51-57 CLAYTON STREET

April 10, 1989

Rc: 53 Clayton Street, Portland, Maine

Your application to construct a 14' X 30' addition has been reviewed and a report is herewith issued subject to the following requirements:

ADDITION

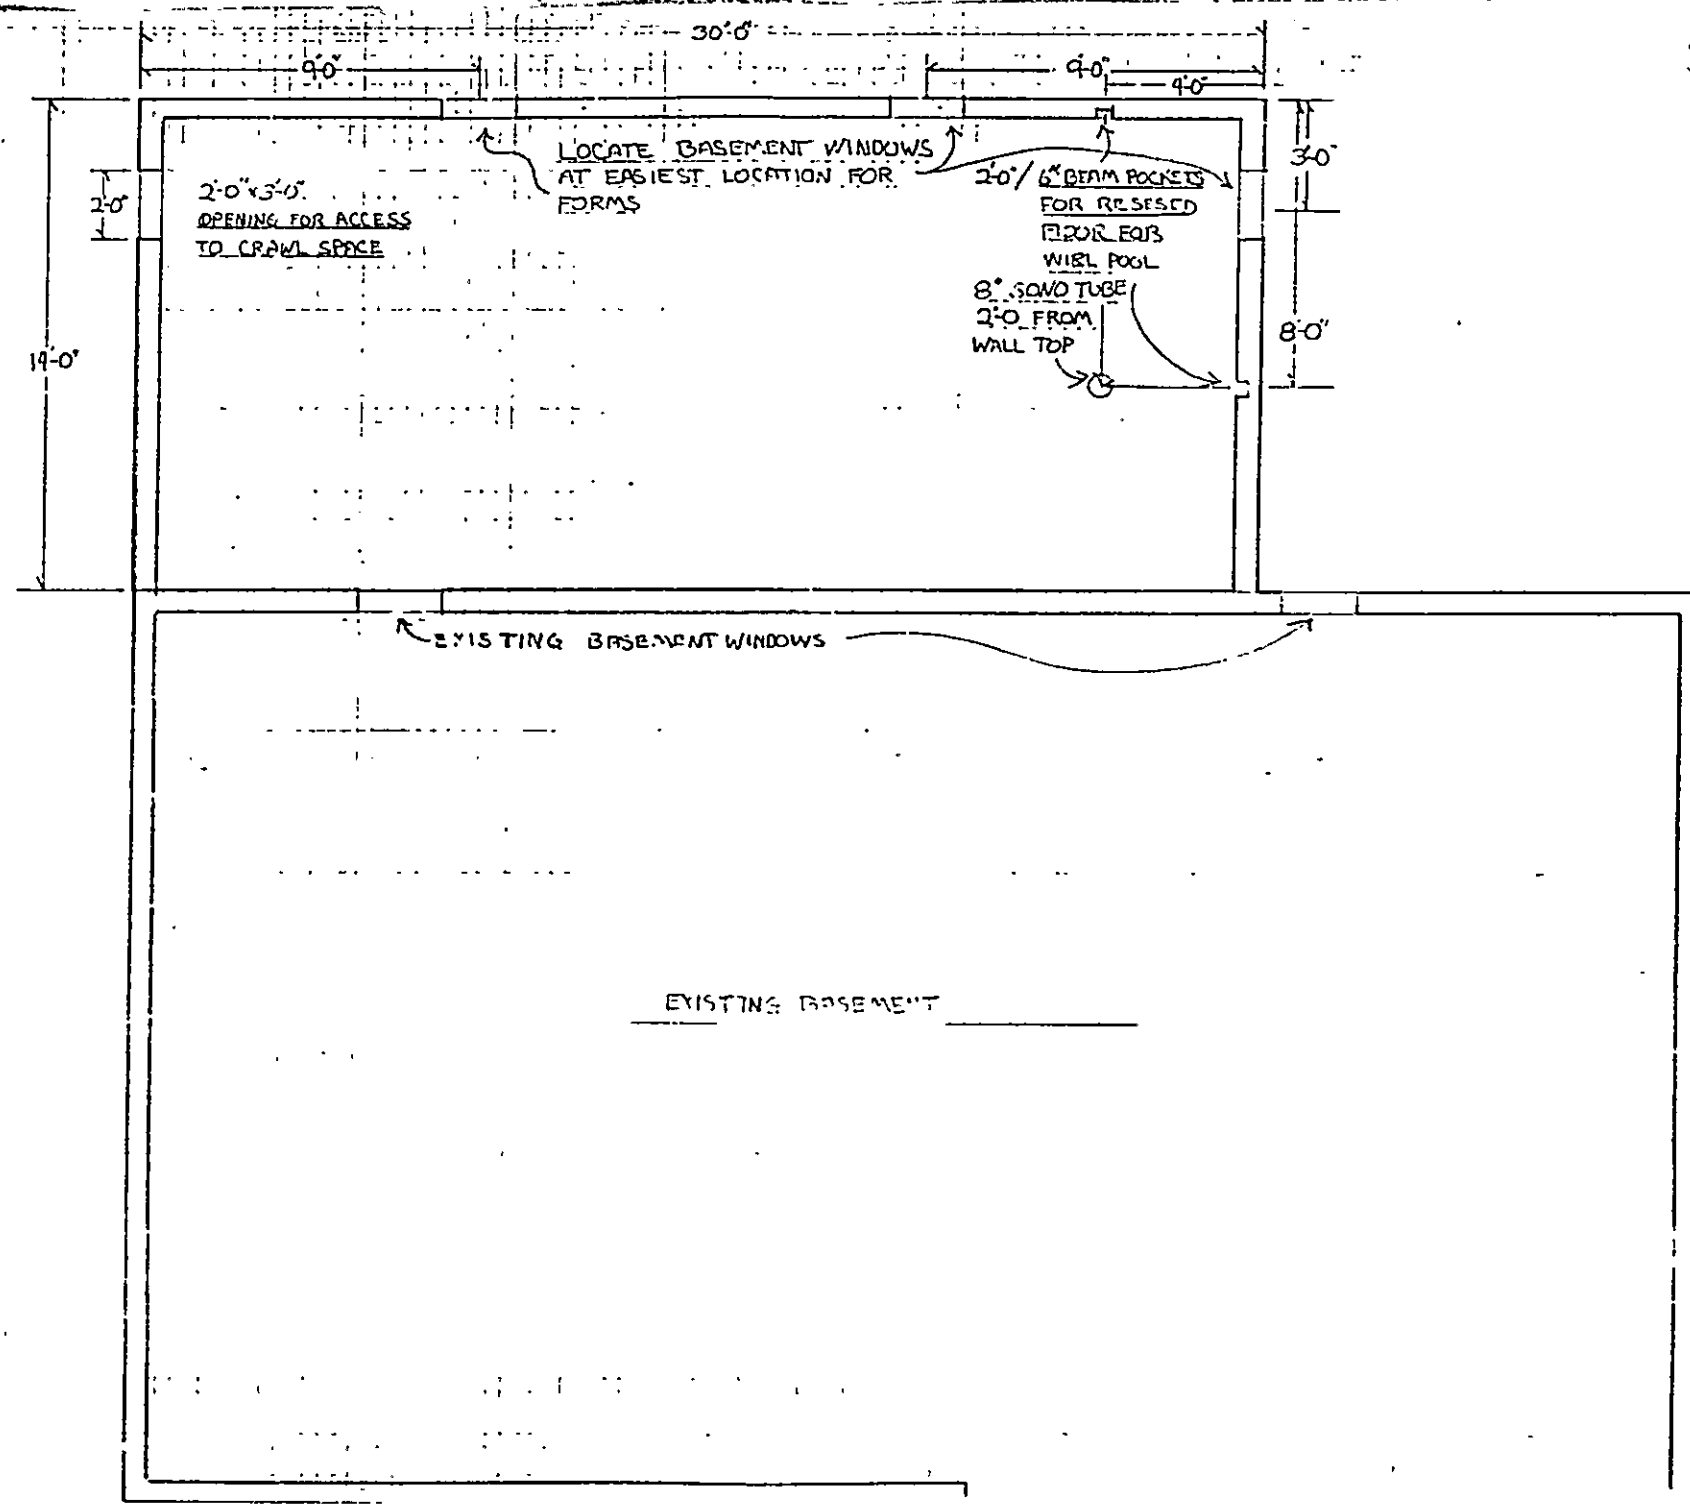
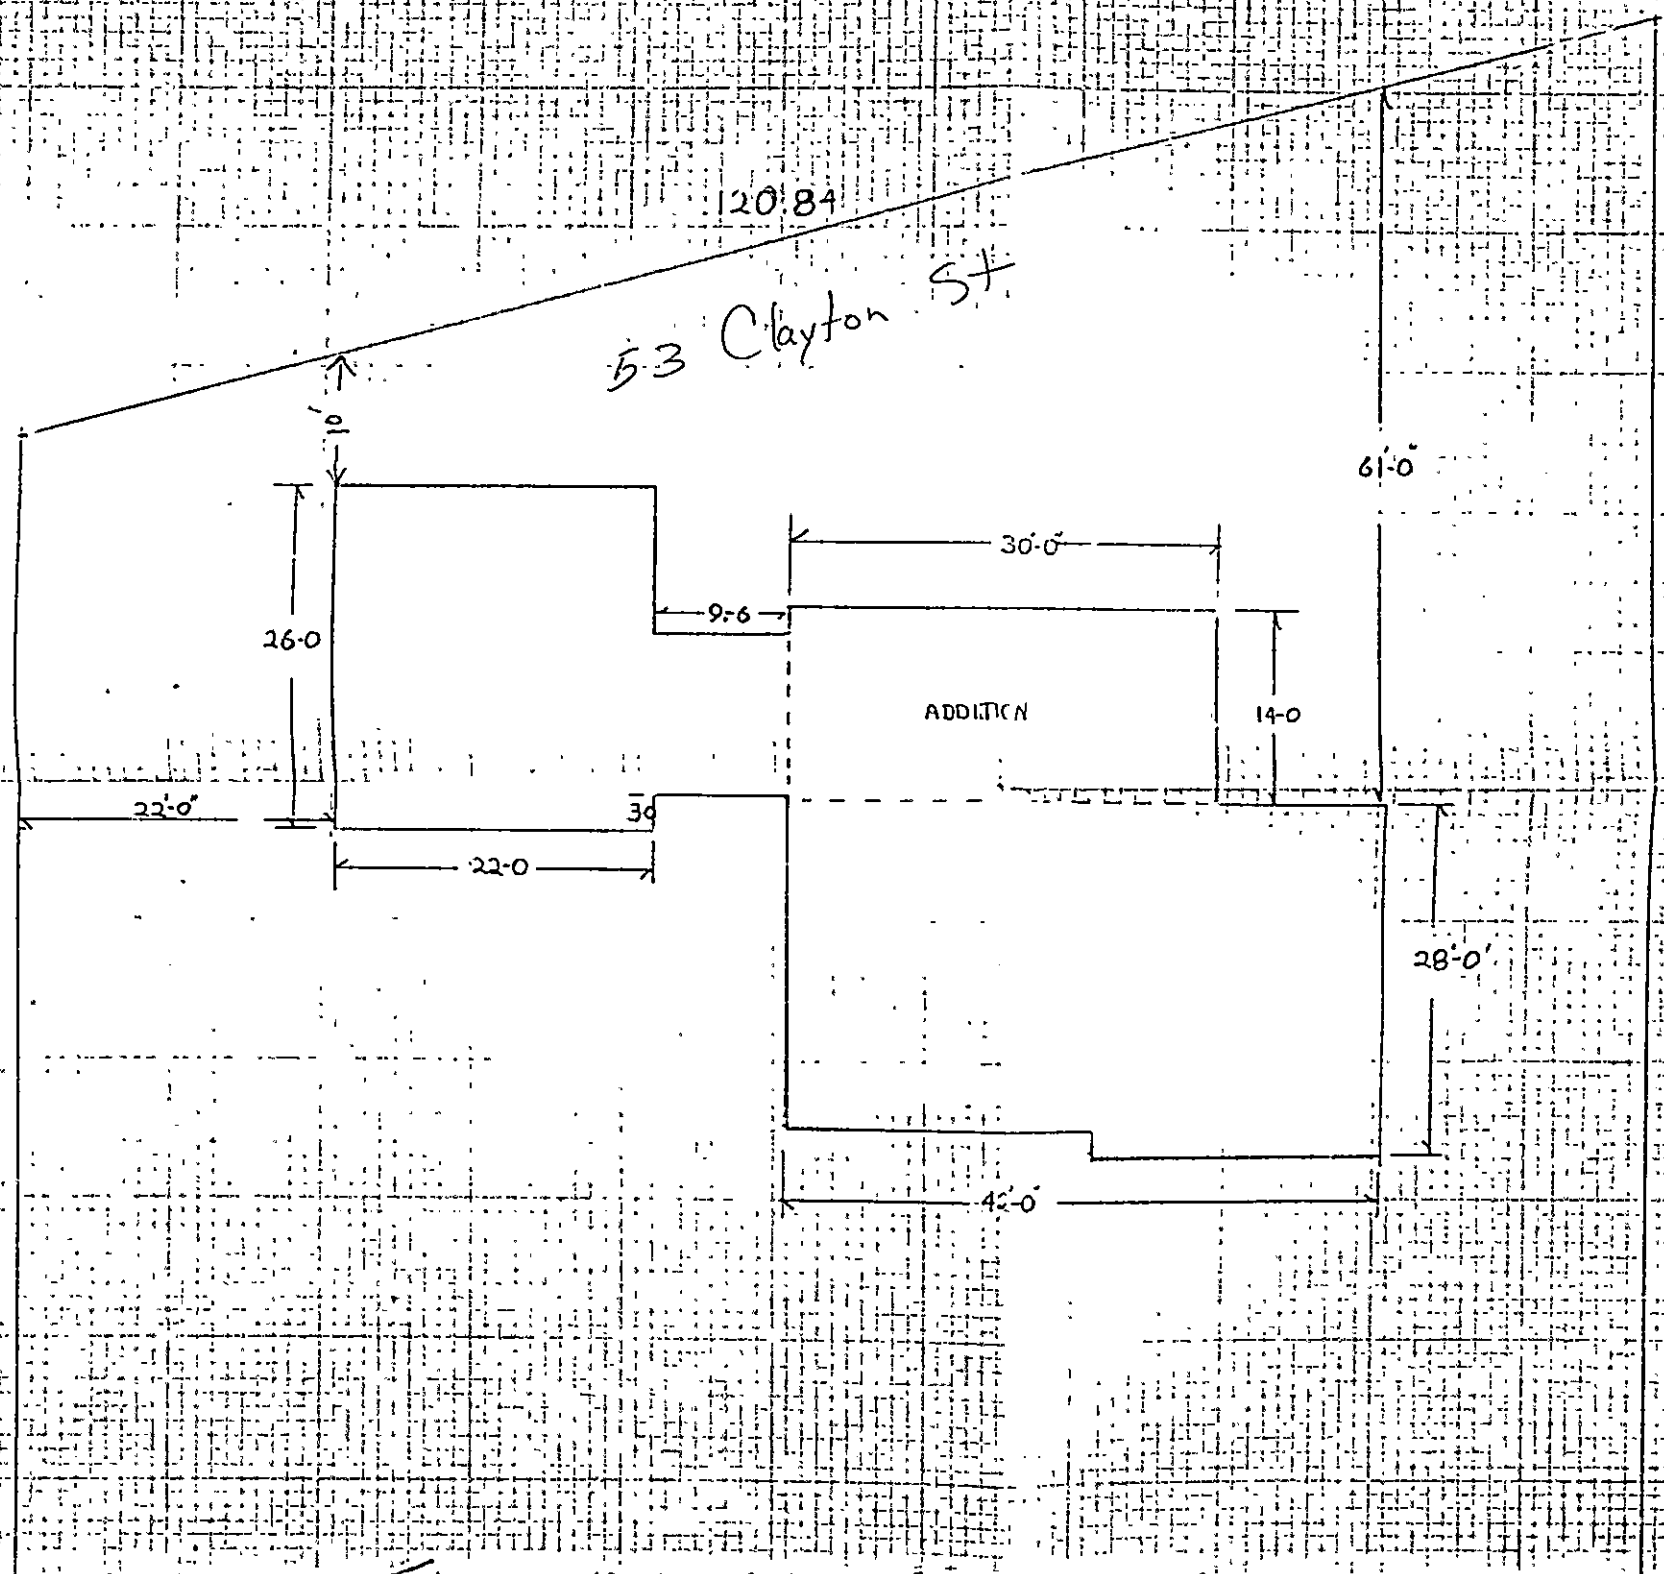
- 1.) The foundation must be a minimum of 8" frost wall.
- 2.) Ventilation for the crawl space shall meet section 709.2 of the Building Code.
